Access Compliance Report

Public Rights-of-Way

Intersection ID: 20587	Main Street: COLONY_RD	Cross Street: FAIRVIEW_RD	Location: SW
ADA ID: 9770B0FE48AB	Ramp Type: Perp	Initial Pass/Fail: Fail	Overall Compliance: No
		Severity Score: 12.5

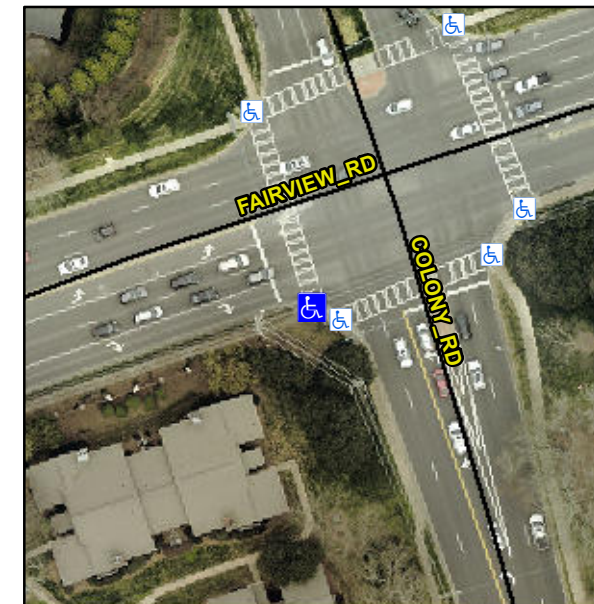
Not Found, R304.5.3

Compliance	Description	Data	Compliance	Description	Data
N/A	Ramp Length (in)	60.0	Yes	Ramp Slope (%)	5.6
Yes	Ramp Width (in)	48.0	No	Ramp XSlope (%)	5.3
N/A	Flare Type LT	N/A	N/A	Flare Type RT	N/A
N/A	Flare Slope LT (%)	N/A	N/A	Flare Slope RT (%)	N/A
N/A	Flare Traversable LT?	N/A	N/A	Flare Traversable RT?	N/A
N/A	Landing Length (in)	N/A	N/A	DWS Provided?	N/A
N/A	Landing Width (in)	N/A	N/A	DWS Contrast?	N/A
N/A	Landing Slope (%)	N/A	N/A	DWS Length (in)	N/A
N/A	Landing X Slope (%)	N/A	N/A	DWS Full Width?	N/A
N/A	Landing Curb? (Y/N)	N/A	N/A	DWS Offset (in)	N/A
N/A	Shared Landing?	N/A			
N/A	Gutter Ponding?	N/A	N/A	Gutter Slope (%)	N/A
N/A	Gutter Lip Ht (in)	N/A	N/A	Gutter X Slope (%)	N/A
N/A	Painted X Walk1?	Yes	N/A	Painted X Walk2?	N/A
	X Walk 1 Direction	To NW		X Walk 2 Direction	N/A
N/A	X Walk 1 Width (in)	109.0	N/A	X Walk 2 Width (in)	N/A
	X Walk 1 Slope (%)	0.6		X Walk 2 Slope (%)	N/A
	X Walk 1 X Slope (%)	2.0		X Walk 2 X Slope (%)	N/A

Remove & Replace Entire Ramp.
